Table of Contents
2022-21 Main Ballot Items

2022 TMS 402/602 Committee Proposed Negative Resolution to Masonry Standard

2022 TMS 402/602 Committee Proposed Change to Masonry Standard

Page 170, Line 1, Figure CC-9.3-1

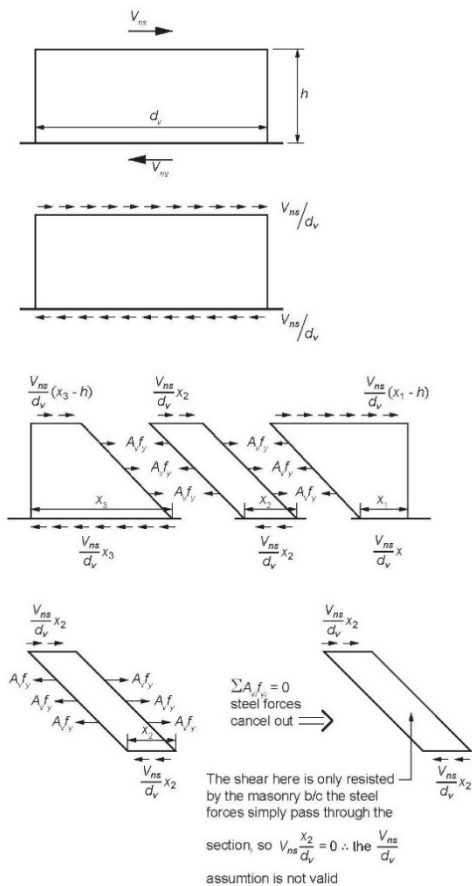
The commentary notes that only the horizontal forces are shown for clarity. The diagrams are in equilibrium in the x direction but are not in equilibrium for in-plane rotation. This means that additional forces are required, or the assumed stress distribution in the reinforcement is not correct, or both.

I will send a figure to accompany this comment item but will try to walk the reader through it textually as well. This item will only consider the forces in the horizontal direction, as assumed in the commentary. The free body diagram in (b) works for a single crack. But consider the scenario where two or more parallel cracks form. Assume they form at a 45-degree angle, similar to the figure.

Now, construct a free body diagram for a strip of masonry running between two cracks. The strip will have a rhomboid shape. Assume the horizontal width of the strip at the top and bottom are x. Based on the commentary's assumptions, the shear force from Vns at the top and bottom will both equal $Vns \cdot x/dv$. In addition, there will be multiple horizontal forces projecting out from both sides representing the horizontal reinforcement, with each force equal to $Av \cdot fy$. Since the horizontal reinforcement forces on the two sides of the masonry strip are equal and opposite, they sum to zero. This means that the forces in the reinforcement pass through the strip from one side to the other side without transferring any load into or from the masonry strip.

Since the shear reinforcement forces have no effect on the strip, an equivalent free body diagram could be constructed for the strip wherein the reinforcement forces are omitted and only the $Vns \cdot x/dv$ forces remain. In either case, the shear forces at the top

and bottom of the strip are resisted by the masonry itself. But this violates the assumptions of the figure because V_{ns} is supposed to be resisted by the shear reinforcement, not the masonry. It appears that one or more of the figure's assumptions are not valid.

I do not think we should include figure (b) because the I have shown two different ways that the figure is not valid, first by showing that the assumptions do not satisfy equilibrium, and second by showing that it contradicts its own assumptions. It's a shame that it didn't work out since it's a simple explanation, but it's no surprise because there has been disagreement in the research community for years about the proper interpretation of the empirical shear equation. I recommend removing figure (b) entirely or, better yet, revising the shear strength equation to a form that has a solid mechanical basis and revising the figure to match. There has been a good amount of research on this latter topic in the past decade or so that could be used as a starting point.

The public commenter suggests that the figure assumptions don't satisfy equilibrium. The committee notes that Figure CC-9.3-1 is intended to only represent an approximation of Equation 9-19 and is limited to horizontal **forces and is intended to explain this equation**. Language is proposed to provide additional background and clarify the commentary figure.

9.3.3.1.2.2 Nominal shear strength provided by reinforcement — The nominal shear strength provided by horizontal reinforcement, as given in Equation 9-19, is an empirical equation based on a best-fit analysis of fully-grouted masonry shear wall tests performed in the 1980s (Anderson and Priestley (1992)). While predominantly an empirical relationship, the form of Equation 9-19 can be approximately represented by the assumptions and free-body diagrams shown in Figure CC-9.3-1, where only horizontal forces are considered. ~~shown for clarity.~~ For walls

Figure CC-12.1-1

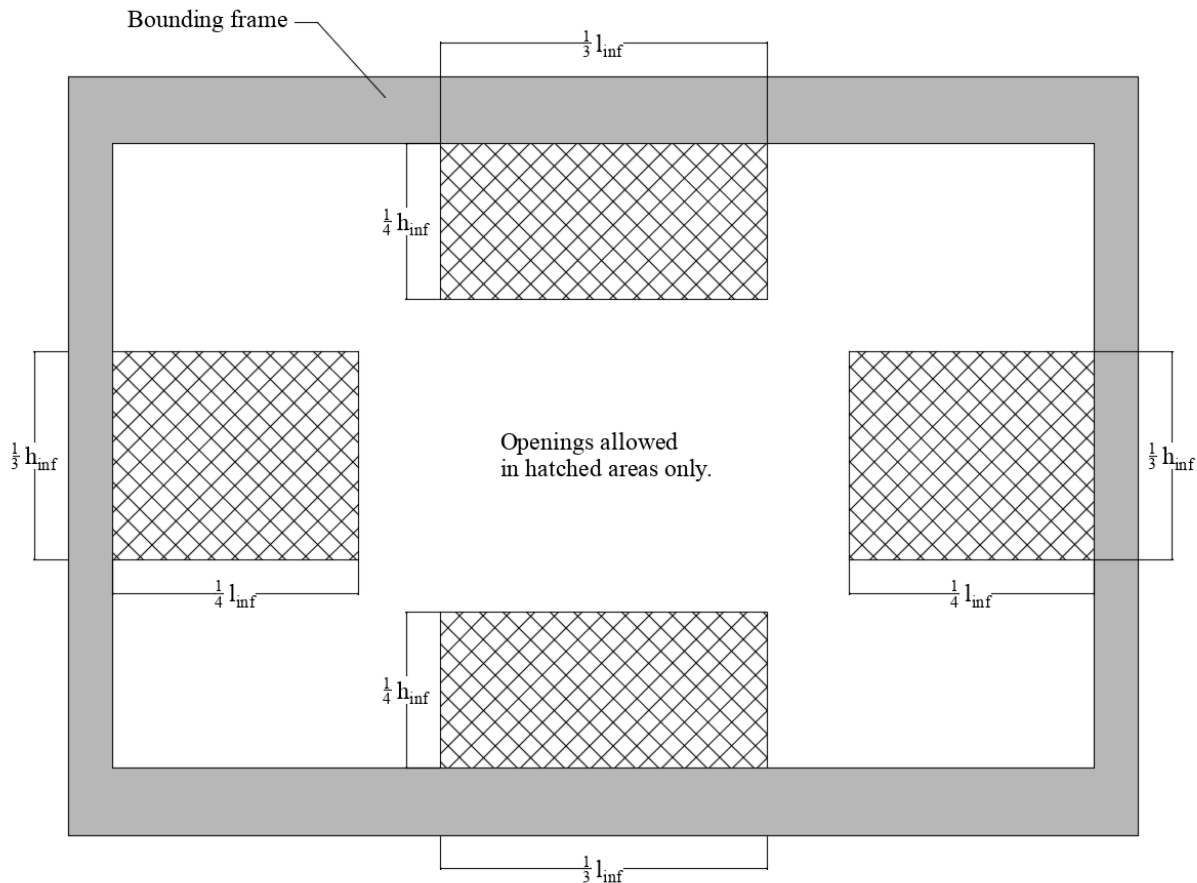
<p>Figure CC-12.1.1</p>	
Comment Non-Voting	Mr. Robert M. Chamra rchamra@buildingdx.com	Corresponding Member: Affirmative without comment.	
Negative	Dr. Daniel P. Abrams d-abrams@illinois.edu	<p>In Sec. 12.1.5.1 the terms “in any dimension” may be misconstrued to include the dimension normal to the infill plane, i.e. the infill thickness. If this wording is interpreted as such, then no openings of any size would be allowed in an infill thicker than 6 inches. I doubt if this is the intention. Perhaps it would be better to replace “in any dimension” with “width or length”.</p> <p>Figure CC-12.1-1 needs more clarification. The bounding frame should be shown as columns and beams for context (rather than shaded rectangles) and the figure should be designated as an elevation view. Dimensions should be given to locate the hatched areas. Dimension lines should follow standard format practice with arrows at their ends. Lines from the dimension lines should be drawn consistently (either hidden from bounding frame or shown, but not both).</p>

Mr. Thomas Michael Corcoran tmcorcoran@comcast.net	<p>Figure CC-12.1-1 requires more definition such as:</p> <ol style="list-style-type: none"> 1. Define l_{inf} and h_{inf} on the figure. 2. Define the white area of the figure. 3. Can the code 12.1.5.1 and 12.1.5.1.1 maximum opening size and cumulative area of openings requirements be shown on the figure? 4. Give the figure a title such as "generic (or common, universal, etc) infill wall elevation". 	
	Ms. Heather A. Sustersic hsustersic@colbycoengineering.com	The proposed language appears to assume that the infill wall is designed to span vertically. What if the wall is designed to span horizontally? Also, please add that the openings should not interrupt bond beams, whether reinforcement is present or not.

The Committee agrees that the allowance of small openings in masonry infills is appropriate. Small openings have negligible impact on the strength or performance of the infill wall in which they are located as long as reinforcement, when required, is not displaced by the opening and the equivalent diagonal strut is not interrupted. A new Figure CC-12.1-1 provides a schematic of allowable opening locations. Research by Dawe and Seah (1989a) indicated the first crack load was essentially unaffected by even large openings within the infill wall, so the suggested limitations on opening size and location are conservative.

Small openings have negligible impact on the strength or performance of the infill wall in which they are located as long as reinforcement, when required, is not displaced by the opening and the equivalent diagonal strut is not interrupted. See Figure CC-12.1-1 for a schematic of allowable opening locations. Openings in excess of those permitted by Sections 12.1.5.1 have the potential to impact structural performance of the equivalent diagonal strut. Research by Dawe and Seah (1989a) indicated the first crack load was essentially unaffected by even large openings within the infill wall, so the limitations on opening size and location are conservative. Infill walls with excessive openings are required to be designed as non-participating infills per Section 12.2. For the purposes of this Chapter, the term openings includes penetrations.

12.1.5.1.2 Location of openings – The limitations of Section 12.1.5.1.2 are sufficient for typical strut widths; however, the designer should verify an opening does not interrupt the equivalent diagonal strut width.

Figure CC-6.1-8 — Development of flexural reinforcement in a continuous wall with centered reinforcement

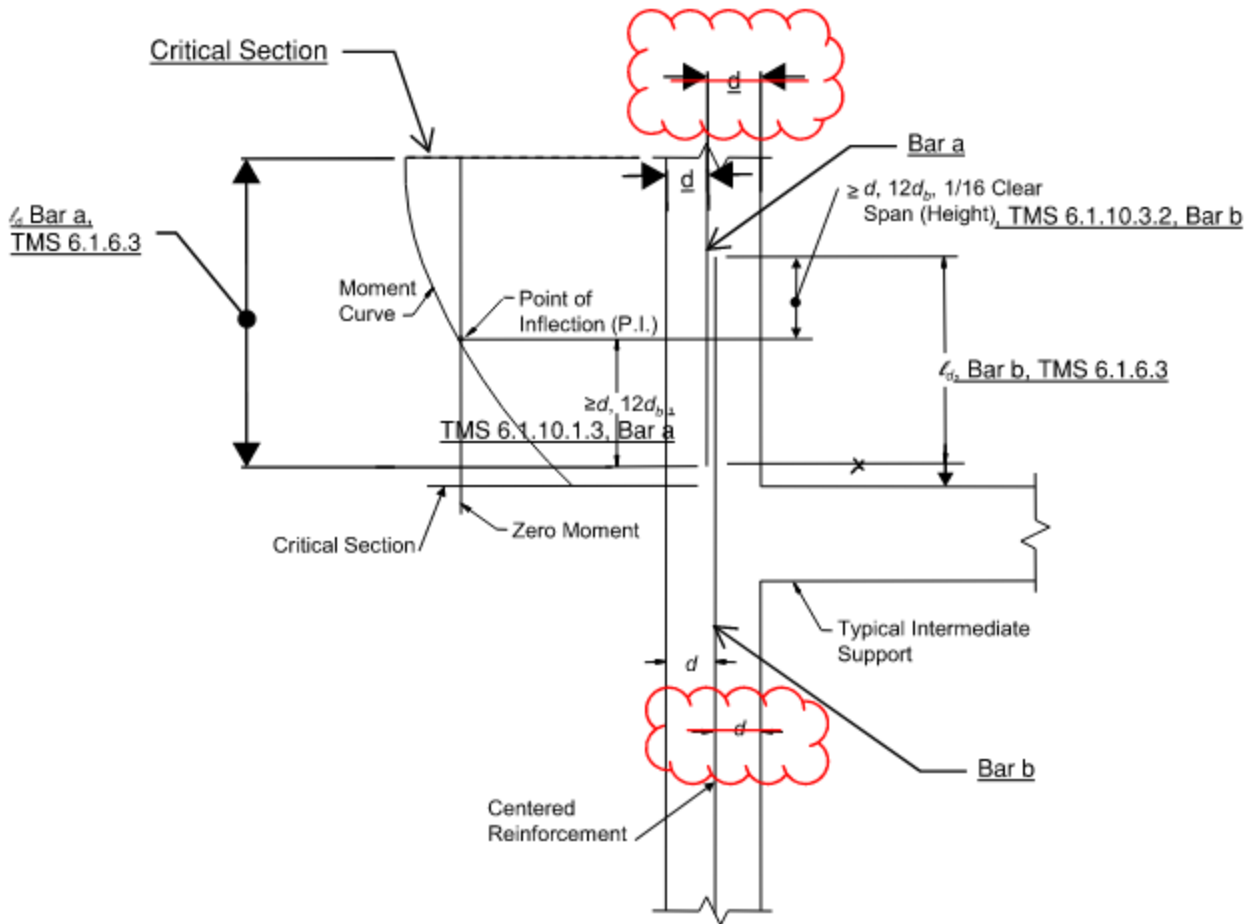
Consider balloting a change to Figure CC-6.1-8 to clarify that the lap shown is not a lap splice but rather the extension of negative moment reinforcement required by Section 6.1.10.

Two affirmative comments related to the graphical depiction of distance “d” on bars ‘a’ and bars ‘b.’ It is important to note that Figure CC-6.1-8 is titled “Development of flexural reinforcement in a continuous wall with **centered** reinforcement” (emphasis added). As such, the subcommittee agrees that it is not necessary to dimension “d” multiple times. One “d” dimension is proposed to be deleted from bars ‘a’ and bars ‘b’. The word “centered” is proposed to be underlined for emphasis.

Proposed changes are underlined in red or clouded in figure CC6.1.8 as shown below.

Figure CC-6.1-5 — Anchorage of joint reinforcement with four longitudinal wires

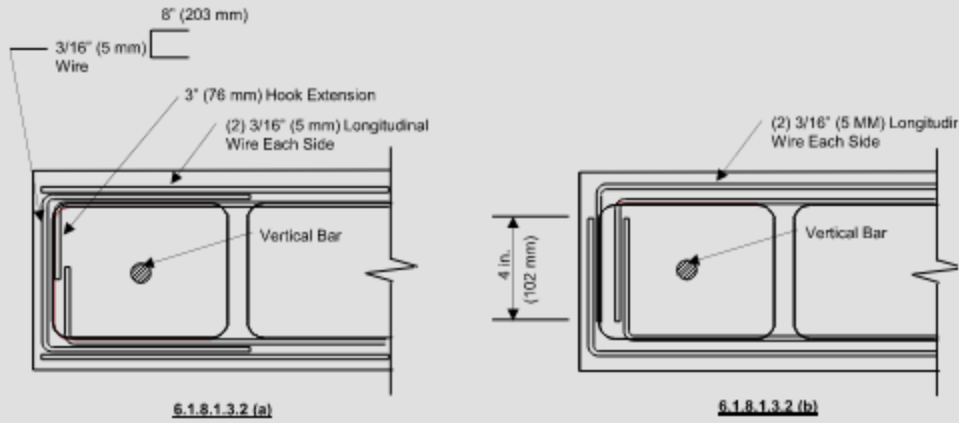
Public Comment 95 was addressed in ballot item 20-RC-012 that received 40 affirmative votes and 3 affirmative with comment votes. Ballot item 21-RC-008 addresses the affirmative comments received on 20-RC-012, but in updating the figure numbering in the working draft, it was discovered that figure CC-6.1-5 is not referenced in the text in either the code or specification.

This ballot proposes to insert a reference to Figure CC-6.1-5 in Commentary section 6.1.8.1.3. A spelling mistake and commentary numbering are also proposed to be corrected.

6.1.8.1.3.2 The options described for anchoring joint reinforcement are illustrated in Figure CC-6.1-45. Both options were used in the testing performed by Baenziger and Porter (2018) and demonstrated performance adequate for use in special reinforced masonry shear walls.

Public Comment #25: Code Commentary: Figure CC-5.1-5 (c)

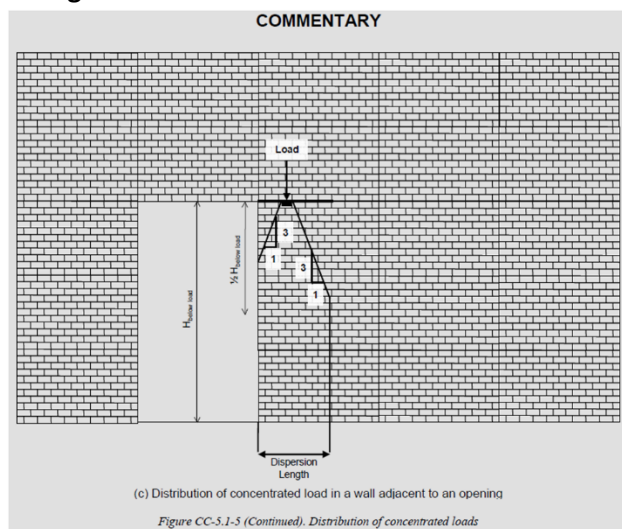
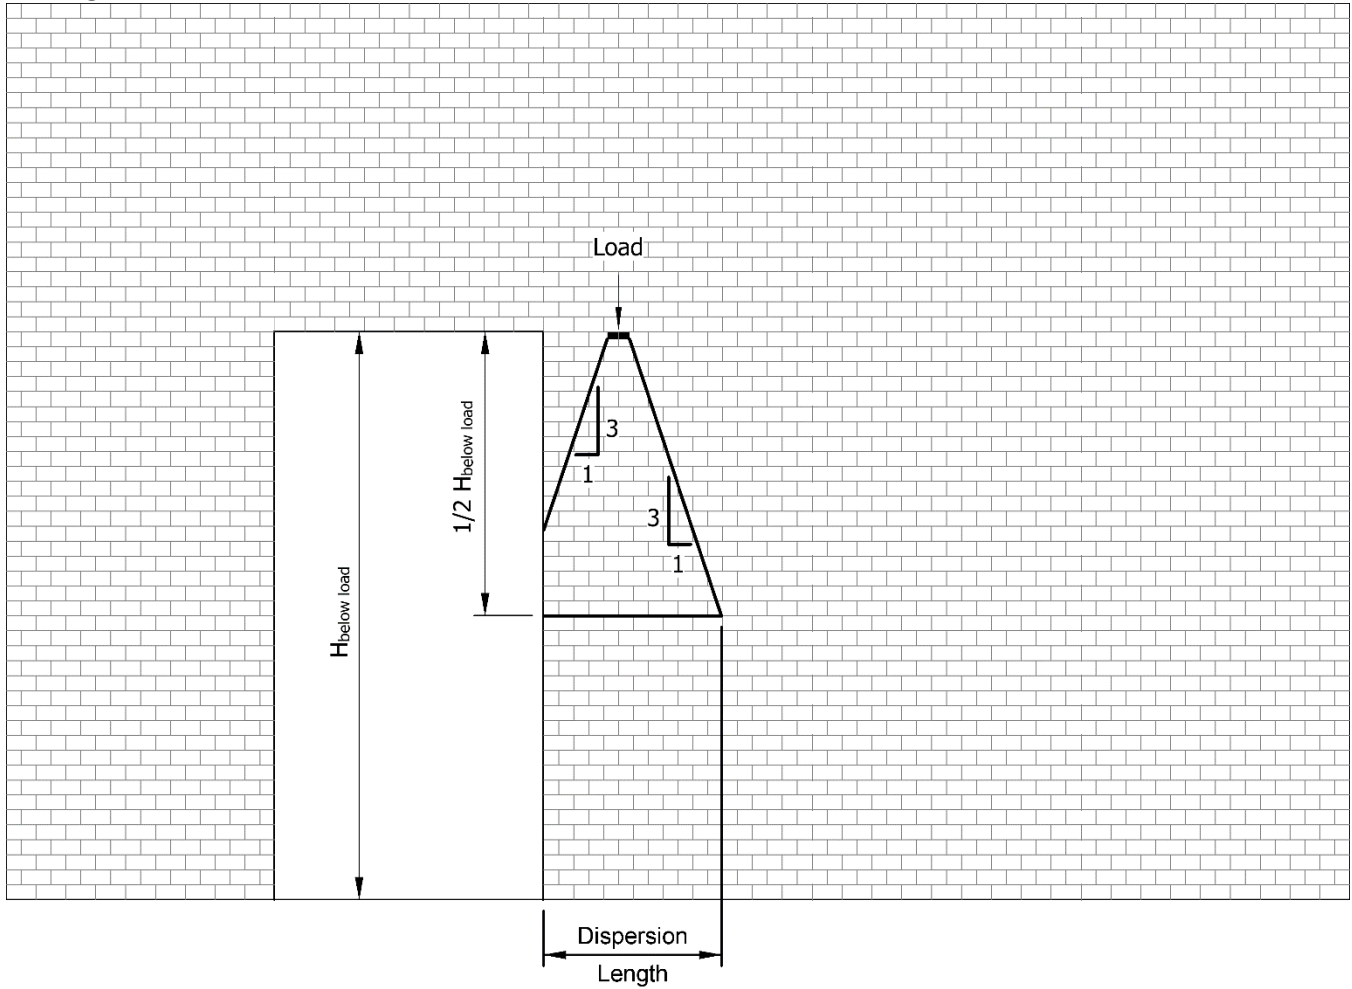
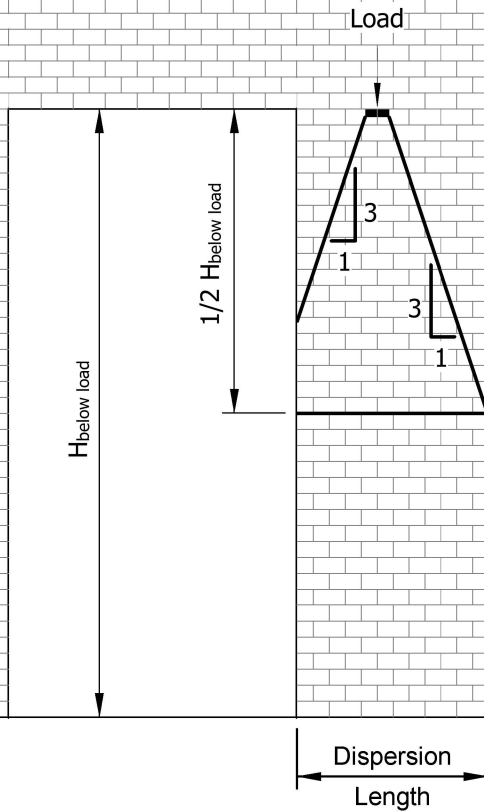
In the figure, the load is not shown as dispersed to $\frac{1}{2} H$ below load as depicted in the figure. That is, the end of the 3:1 line on the right-hand side does not terminate at the half-height point of the wall below the load. I count 14 courses of masonry above the termination and 19 courses of masonry below the termination. Consider changing the line termination so that it is at the mid-point of the height.

Subcommittee Comments: A previous version of this ballot/image received one negative and one affirmative comment. The negative was found persuasive in a virtual subcommittee meeting and this version incorporates the changes requested by all of the comments.

Figure CC-13.3-1 Cross-section of typical adhered masonry veneer supported by light frame

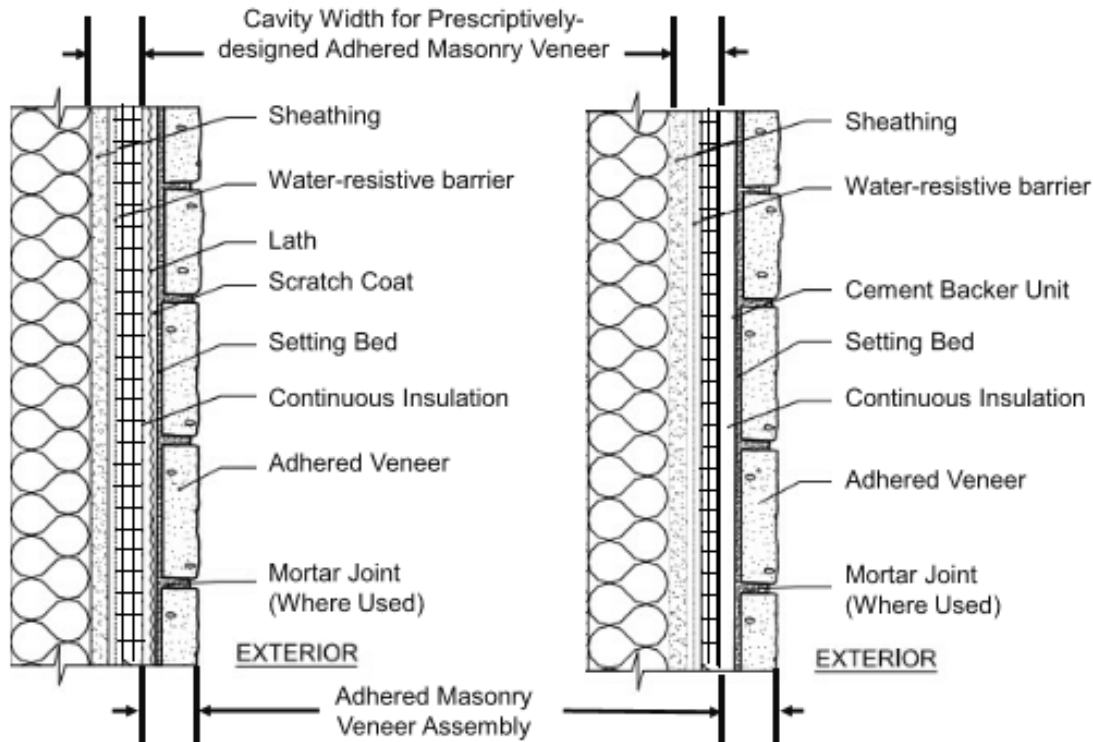
Fig. CC-13.2-4 provides a graphic description for anchored veneer, so a new figure (CC-13.3-1) is recommended to graphically show how the definition of cavity and veneer assembly is applied to adhered veneer.

The cross-section of a typical adhered veneer wall where the backing is either wood or metal studs is shown in Figure CC-13.3-1.
